CALIFORNIA COASTAL COMMISSION

**RECORD PACKET COPY****W 7c****STAFF RECOMMENDATION****ON CONSISTENCY DETERMINATION**

Consistency Determination No.	CD-72-00
Staff:	MPD-SF
File Date:	7/3//2000
45th Day:	8/17/2000
60th Day:	9/1/2000
Commission Meeting:	8/9/2000

Restoration of Upper Newport Bay through various dredging and habitat modification activities (Exhibits 8-13)

Figure 5.4 Recommended Plan Loss of Mudflat Habitat

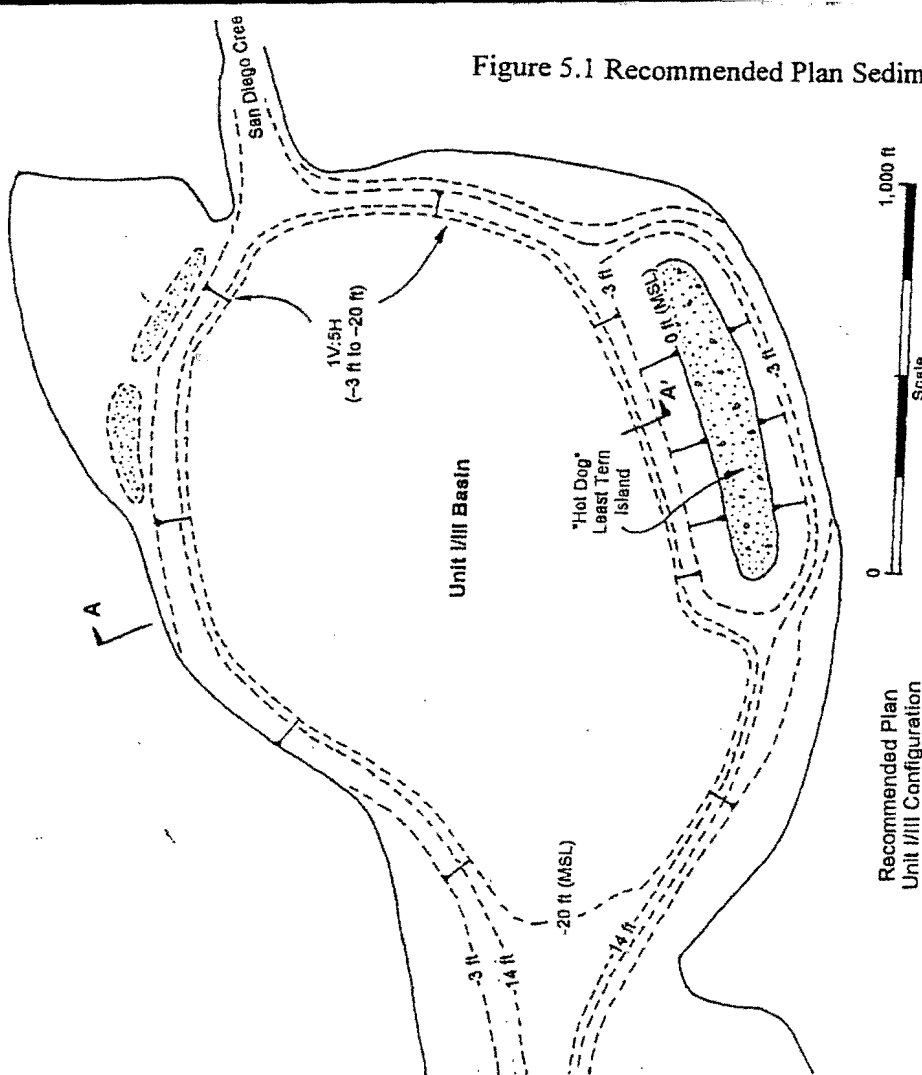
Concerning the mitigation test of Section 30233, even though the project constitutes restoration and thus an overall habitat improvement, and even though it would be less damaging than the "no project" alternative, it nonetheless involves habitat alteration between various types of intertidal habitat (Exhibit 10). The U.S. Fish and Wildlife Service has recommended several measures to minimize intertidal habitat disturbance (Exhibit 13), including that the Corps implement no greater than a 10% change to any one type of intertidal habitat in the Bay. The Corps has agreed to this restriction, stating in a letter to the Fish and Wildlife Service (Exhibit 14):

We are aware of your concern for losses of intertidal mudflats in excess of 10%. Due to time constraints given by the local sponsor's need to have this project included in the Water Resources Development Act (WRDA) of 2000, we are unable to rigorously model another alternative. However, we believe that further refinement during the post-authorization, Preconstruction, Engineering, and Design (PED) phase, prior to construction, will further reduce the permanent intertidal mudflat habitat loss to within agreed upon limits, while retaining the longest possible interval between maintenance dredging cycles. Therefore, the U.S. Army Corps of Engineers will continue to work throughout the project's design phase to further refine this alternative to reduce the initial loss of intertidal mudflats while continuing to meet all TMDL requirements. Our

intent will be to approach both a minimum 20-year dredging cycle and a maximum 10% loss of any habitat type.

1. The Corps investigate modifications to the Unit II basin design to reduce the loss of intertidal mudflat.
2. The Corps restore additional upland areas to intertidal mudflat to reduce the permanent loss this habitat to no greater than 10 percent (includes the consideration of the 1st recommendation).

Additional design modifications will be investigated during the PED phase to further reduce the loss of intertidal mudflat habitat. These investigations will include the possibility of reducing the size of the Unit II basin by restricting the expansion of the western edge of the basin. Any Unit II basin modification will be investigated by using the numerical model during the PED phase.

1. Unit II basin design modifications will be investigated during PED phase in order to lessen the overall loss of intertidal mudflat habitat without diminishing sediment trapping capabilities. This effort will be combined with the possible addition of the restoration of other upland areas to intertidal mudflat habitat in the ecological reserve. These additional areas are mentioned in Chapter 5 (see *Additional Restoration Measures*). All of these measures will be pursued to better meet the 10% habitat change constraint for the loss of intertidal mudflat habitat.
